**TOWN OF ACTON
INTERDEPARTMENTAL COMMUNICATION**

Date: September 11, 2009

To: Manager Department
From: Engineering Department
Bruce M. Stamski, P.E., Town Engineer/Director of Public Works
Re: Spruce Street Tulip Tree Hearing

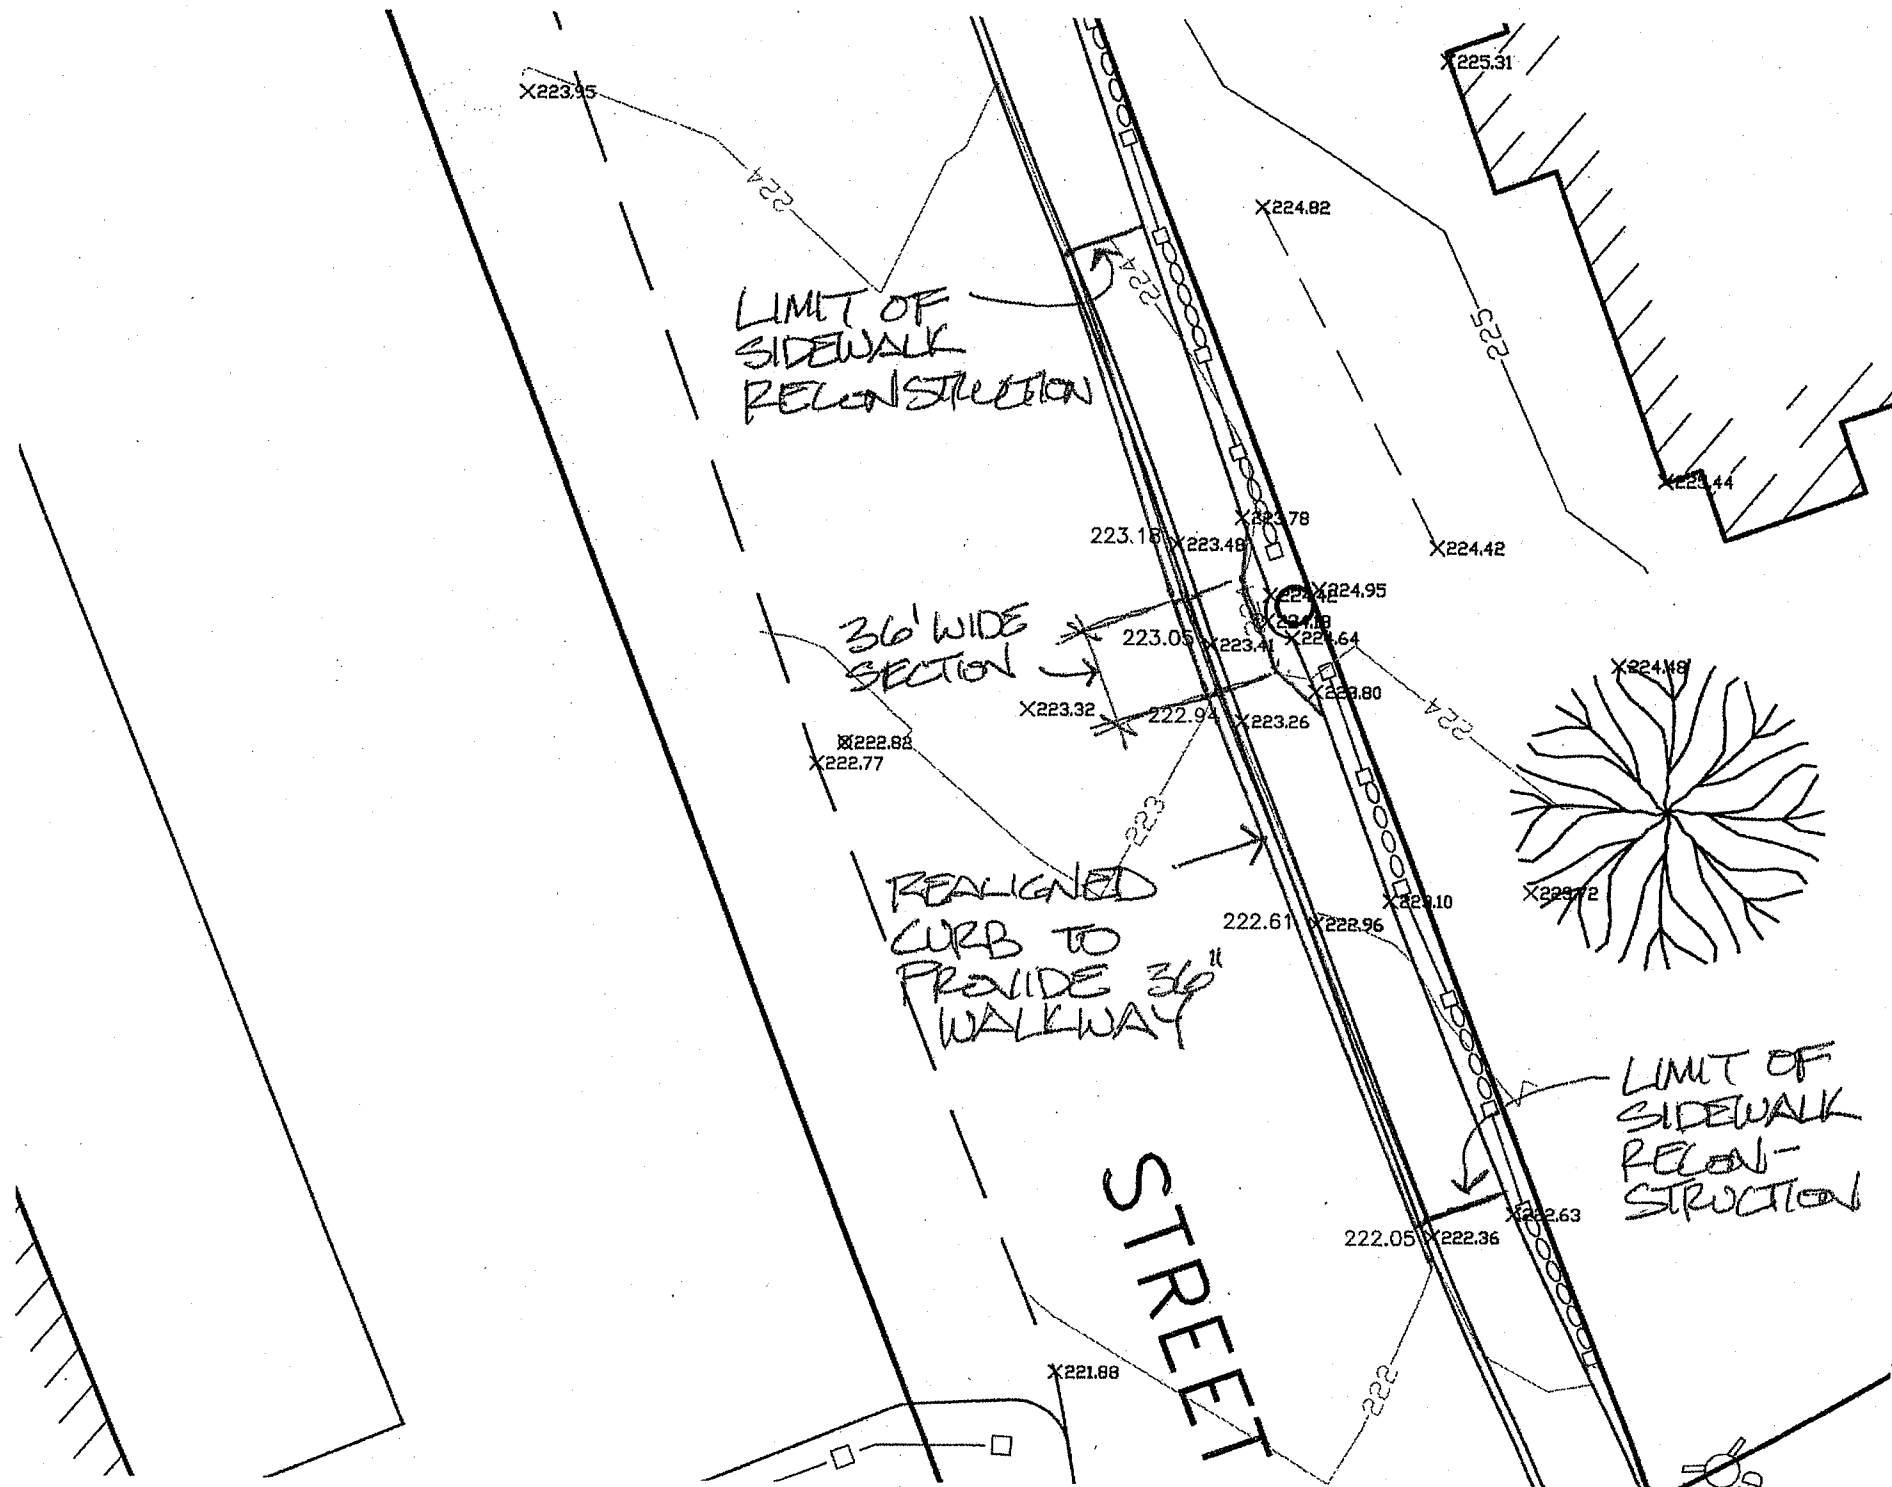
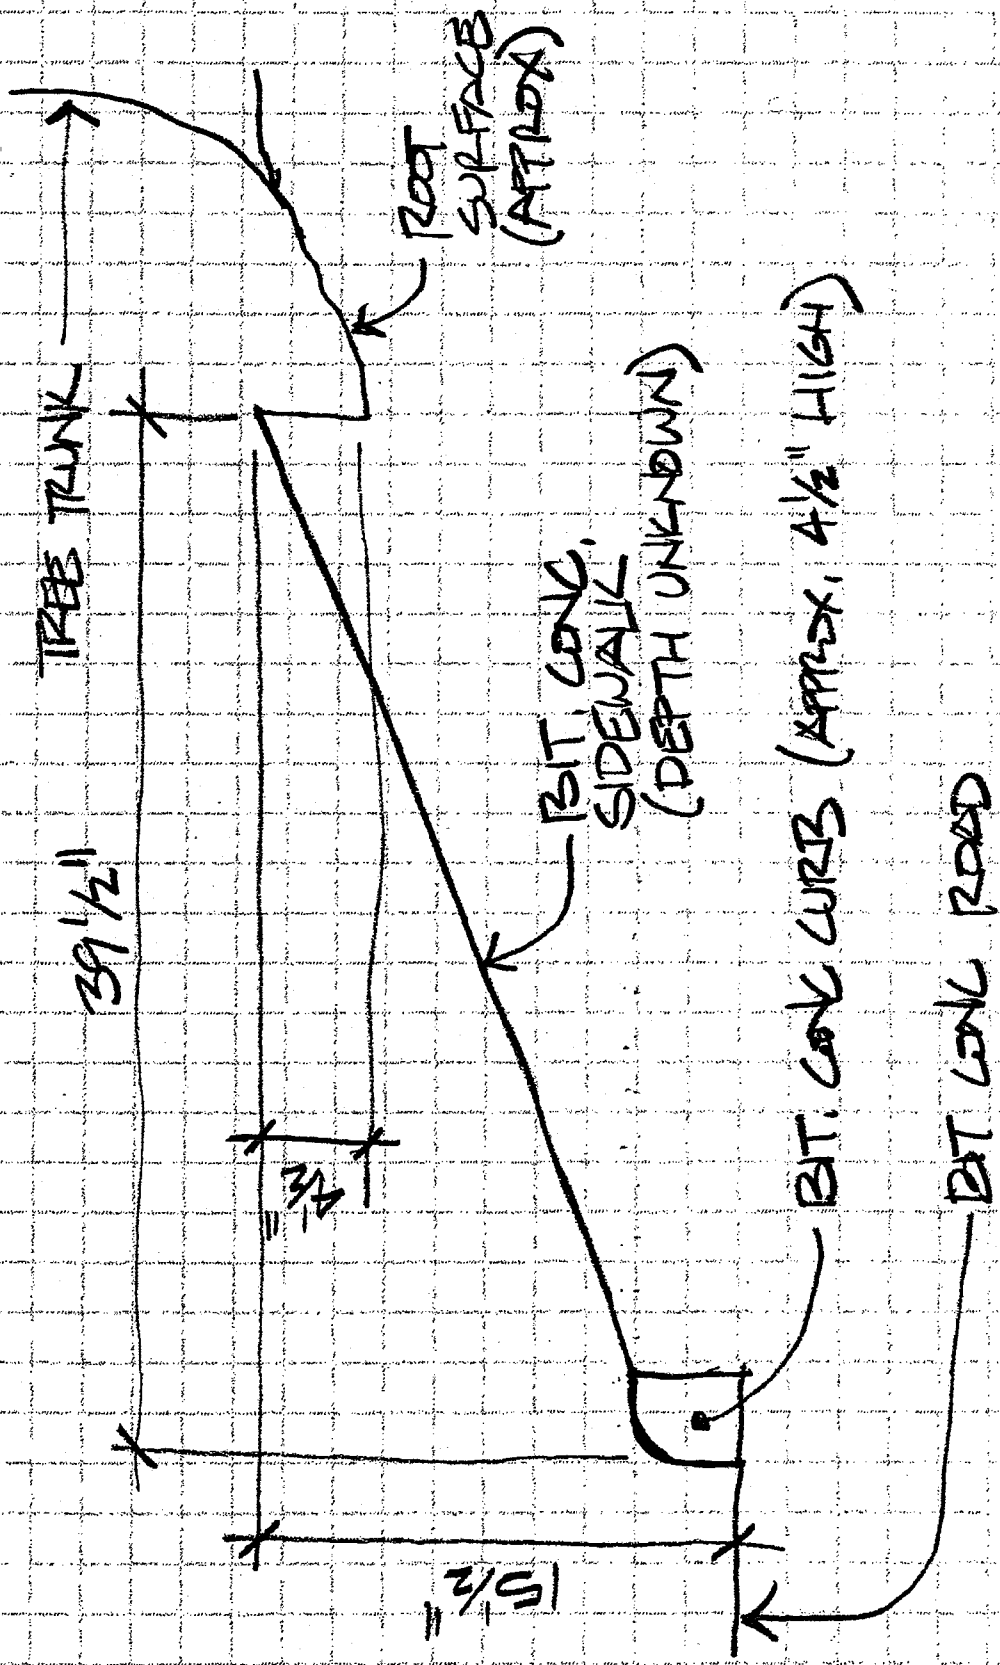
Mr Thomas Doolittle, a landscape architect submitted a report with sketches of a proposal to have the sidewalk narrow to 3 feet in width, installing a curbing 10 inches high at the tree and replacing 50 feet of sidewalk. The Engineering Department estimates the cost of this proposal to be in the vicinity of \$5000. Per Mr. Doolittle's report "an interpretation of the regulations should be sought" to confirm that the narrowing of the walk for a short distance is acceptable. I have been in contact with the compliance officer at MAAB. He was to write a memo on this, however he is on vacation until Monday. Assuming Mr. Doolittle's proposal is MAAB compliant the Engineering Department still has some major concerns and does not recommend this proposal for the following reasons.

1. A 10 inch high curb (normal curb height 6 inches) coupled with the narrow width creates a hazard to pedestrians. A miscue by a child on a bike, a person in wheelchair or using a walker will have them falling into the street.
2. Our sidewalk plows need a minimum of 4'-6" clearance. The manufacture has told us that the machine will flip over if it goes off a curbing more than 8 inches high. The Highway Department will have to dispatch a snow blower to clear this area thereby slowing our ability to get the sidewalks passable after a snowstorm.
3. The tulip tree will continue to grow. Since 1993 the tree has grown from 18 inches in diameter to 24 inches. With the absolute minimum width of 3 feet butting up to the tree it will only take a few years for the sidewalk to be non compliant in width.

4. This proposal requires installing granite curbing extending below the road surface by 14 inches. The Tree Warden has expressed concerns about damaging the root system of the tree digging this deep 3 feet off the tree.

If an easement can be obtained from the Klingers I recommend relocating the sidewalk to the back of tree.

If an easement can not be obtained I recommend removing the tree, repairing the sidewalk and planting a replacement tree at a cost of around \$2000.

PROPOSED SECTION NTS

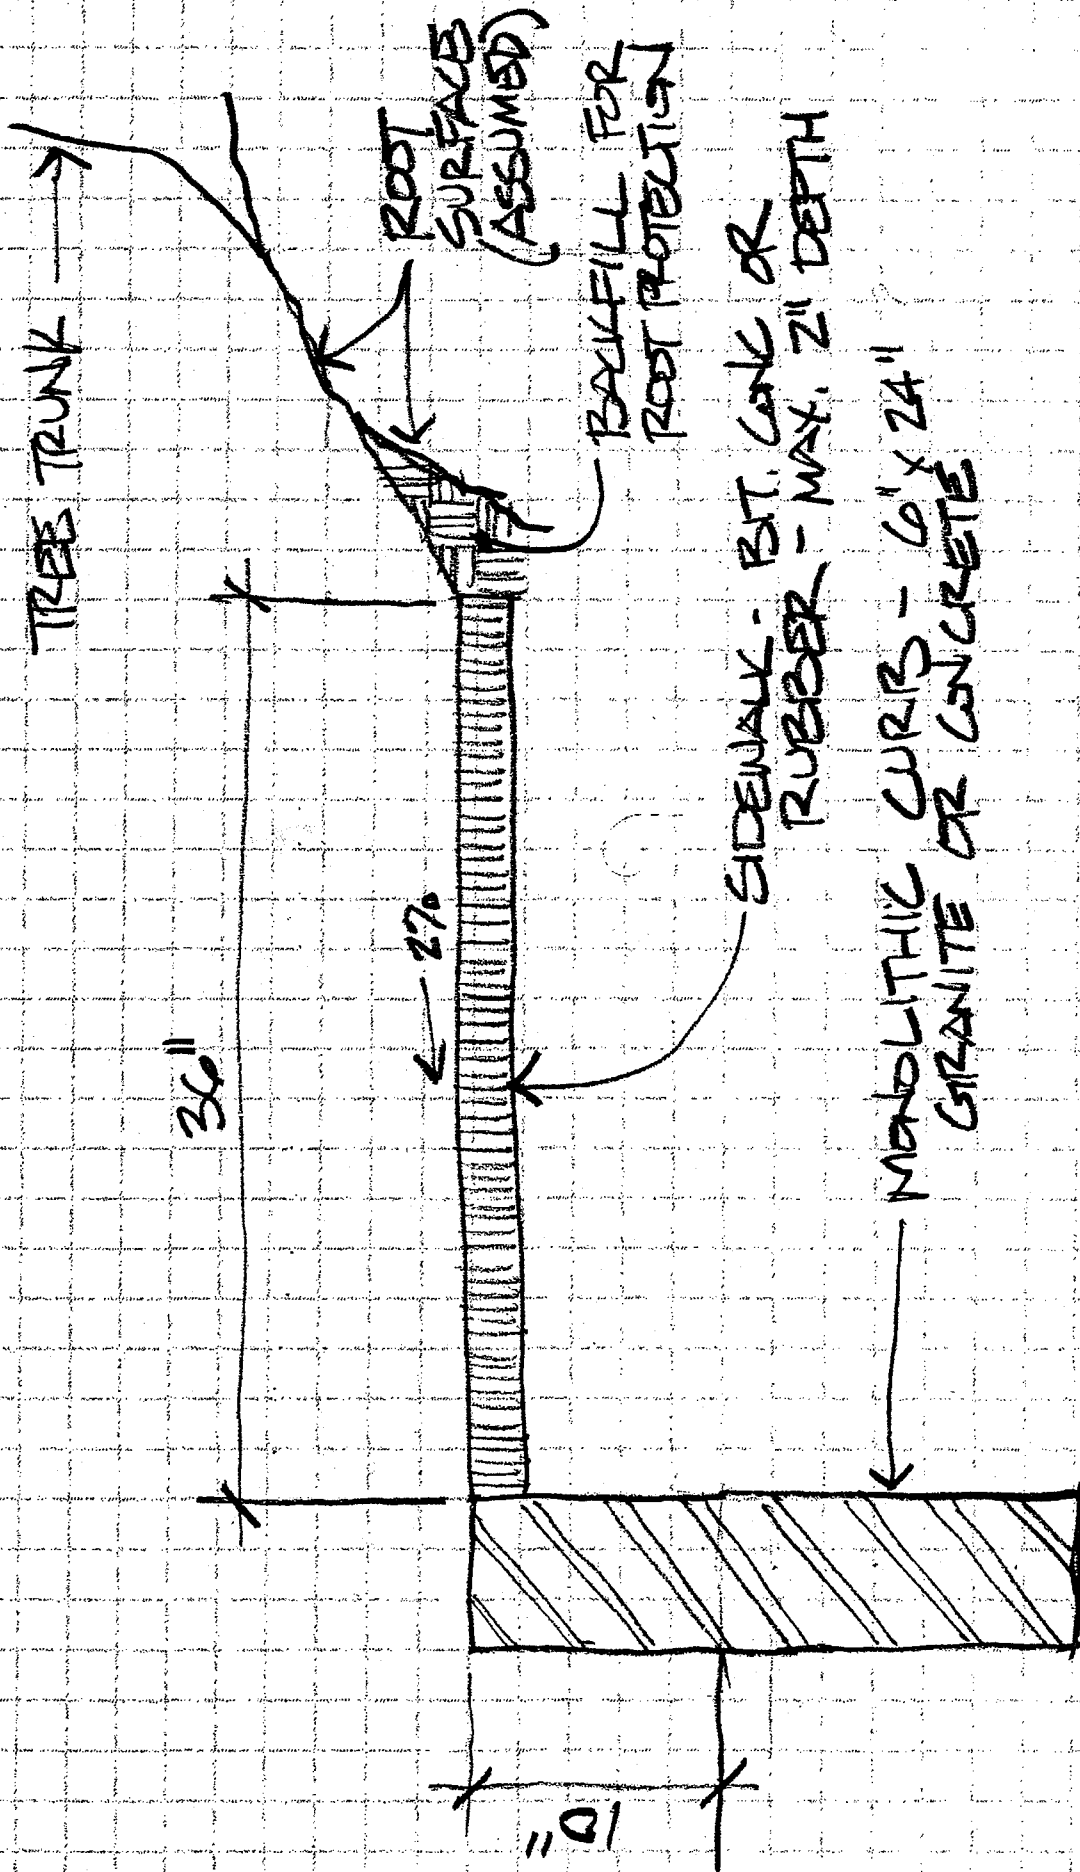
Having said the above, please be advised I will not recommend the to Selectmen that a very high curb coupled with a narrow sidewalk be constructed regardless if it meets the regulations or not. The combination creates a hazard to pedestrians. In addition we have to assume the tree will keep growing and that in a year or two we will have additional root damage to contend with. I would be hard pressed to recommend spending approximately 5K to build a substandard sidewalk which may have to be redone in a couple of years.

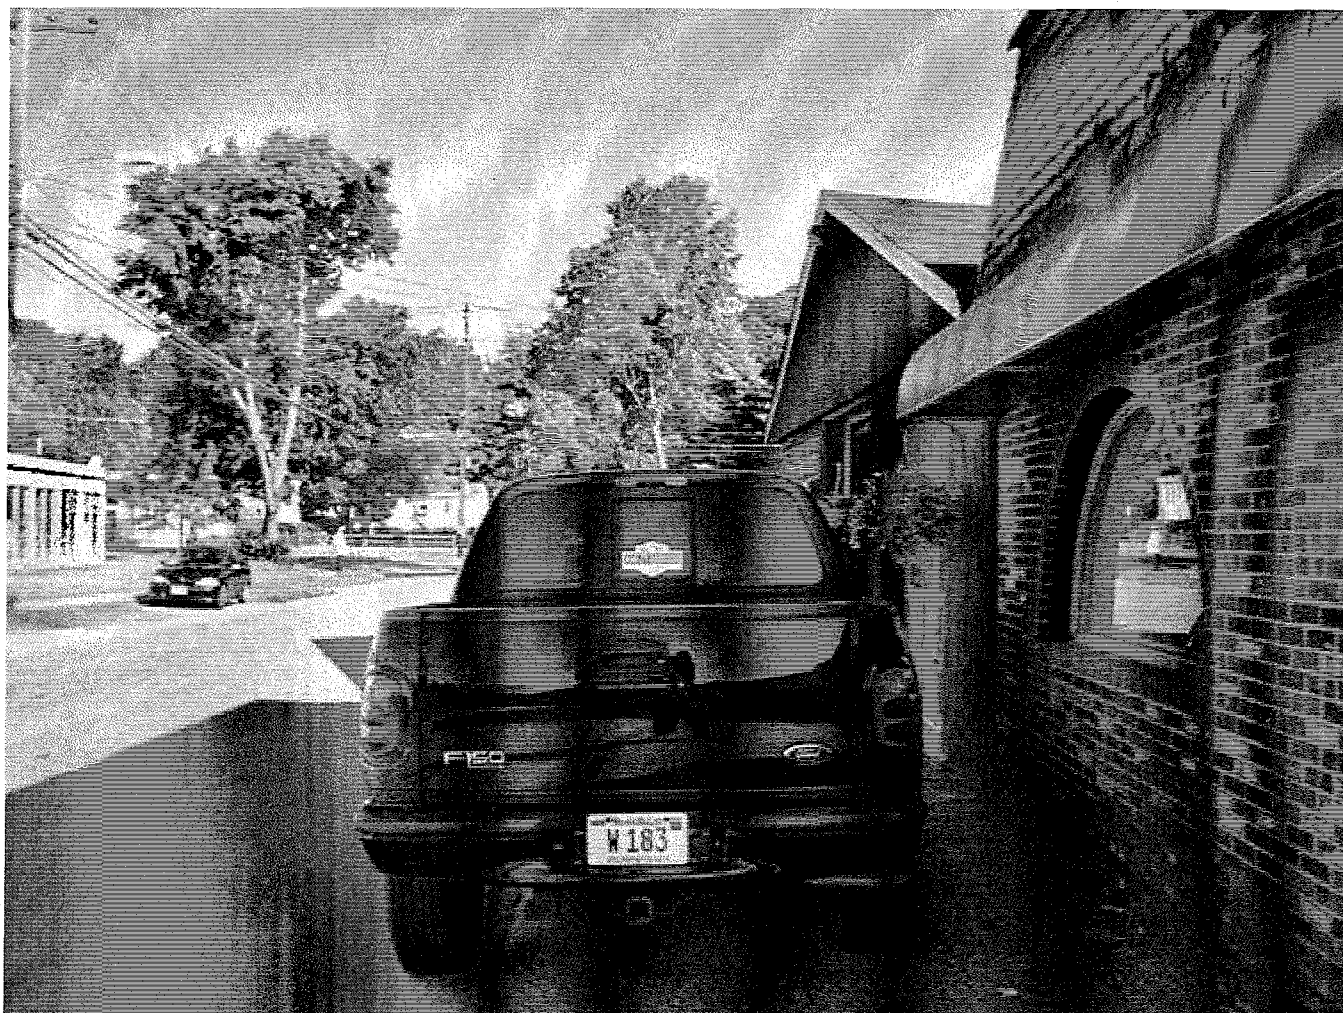
Mr Klinger, whose property abuts the tulip tree, suggests something similar to Doolittle's proposal with an added speed bump. Our objections to the narrow sidewalk are noted above. Speed is not an issue so a speed bump is not recommended. His plan also requires rerouting buses which would require approval of the School Department. He has an estimate of \$2500 which does not include the required curbing or the cost of the speed bump. The total cost is probably 3 times his estimate.
